Comment Form for 1st Draft of Standard PRC-023-1 — Transmission Relay Loadability

Comments on NERC Line Loadability Standard PRC-023 Reference

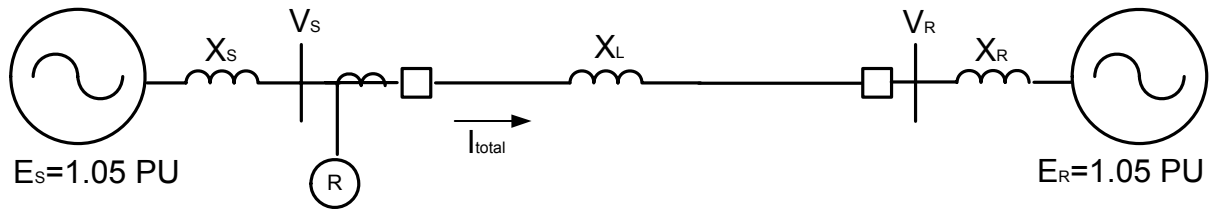
The maximum allowable reach for a mho characteristic relay at the line angle of 90° is:

$$Z_{90} = Z_{relay30} / \cos(90^\circ - 30^\circ) = (0.739X_L/\sqrt{2}) / \cos 60^\circ$$

So, the use of a 30° power factor angle as recommended in R1.3.1 offsets the safety margins that were applied and allows a slightly longer distance relay reach of 104.5% of the line impedance. This is not enough reach for a zone 2 relay to provide adequate protection for the line. The maximum power transfer approach, as used in R1.3.1, is useless in justifying adequate zone 2 settings for long lines!

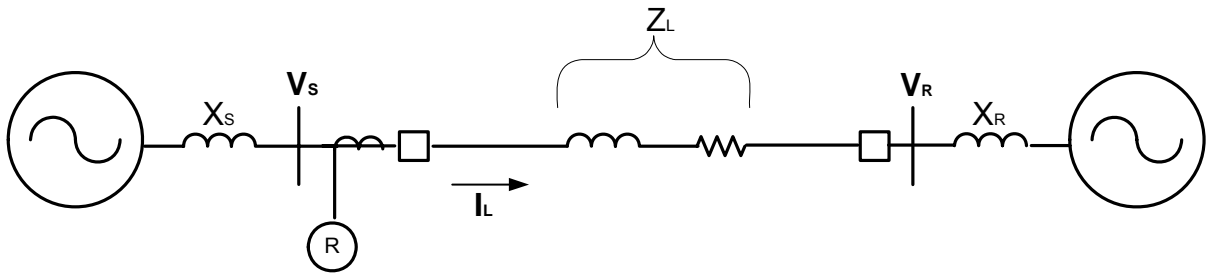
This shows that the maximum allowable reach of a mho characteristic relay at the line angle is approximately equal to $(X_S + X_R + X_L)$. This method will only allow a mho characteristic relay to overreach the line impedance by the same percentage that $X_S + X_R$ is to the line impedance X_L .

$$Z_{90} = 0.996 \cdot X_L [1 + (X_R + X_S)/X_L]$$

As in R1.3.1, R1.3.2 applies the relay reach at a power factor angle of 30° instead of the correct angle of 45° . Using 45° results in even less allowable relay reach.
